# UNITED STATES PATENT AND TRADEMARK OFFICE

APPLICATION NO.	FILING DATE	FIRST NAMED INVENTOR	ATTORNEY DOCKET NO.	CONFIRMATION NO.
10/599,970	06/19/2007	Yo Sawamura	40404.69/ko	7500
54968	7590	04/24/2009		
ROHM CO., LTD. C/O KEATING & BENNETT, LLP 1800 Alexander Bell Drive SUITE 200 Reston, VA 20191			EXAMINER DANG, KHANH	
			ART UNIT 2111	PAPER NUMBER
			NOTIFICATION DATE 04/24/2009	DELIVERY MODE ELECTRONIC

# Office Action Summary

**DETAILED ACTION**

**Fig. 3**  
**Prior Art**

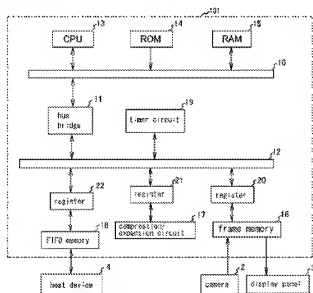
Claims 5 and 6 are rejected under 35 U.S.C. 103(a) as being unpatentable over the acknowledged prior art of Fig. 3 (APA) in view of Kopet et al. (Kopet, 5699460).

The APA, in Fig. 3, which is reproduced below for ease of reference and convenience, discloses an image processing device comprising: a high-speed bus (10) and a peripheral bus (12) linked via a bus bridge (11); a CPU (13) arranged to carry out

computations and control of image processing; a data transceiving FIFO memory (18) arranged to carry out transceiving of image compression data with a host device (4); a frame memory (16) arranged to store image expansion data and to display the data on a display panel (3); and a compression/expansion circuit (17) arranged to carry out compression of image expansion data and expansion of image compression data; wherein the CPU (13) is connected to the high-speed bus (10), and the data transceiving FIFO memory (18) is connected to the peripheral bus (12). See also paragraphs [0003] to [0004] of the specification.

The APA does not disclose that the frame memory (16) is connected to the high-speed bus (10).

However, connecting a frame memory to a high speed bus is old and well-known as evidenced by at least Kopet. Kopet, in Fig. 2, which is reproduced below, discloses

It would have been obvious to one of ordinary skill in the art at the time the invention was made to connect the frame memory 16 to the high speed bus 10, as taught by Kopet, for the purpose of providing higher bus speed for image processing.

With regard to claim 6, Kopet also discloses that the compression and decompression circuit 410 is connected to the host bus or high speed bus HBUS. Thus, it would also have been obvious to one of ordinary skill in the art at the time the invention was made to connect the compression/expansion circuit 17 to the high speed bus 10, as taught by Kopet, for the purpose of providing higher bus speed for image processing.
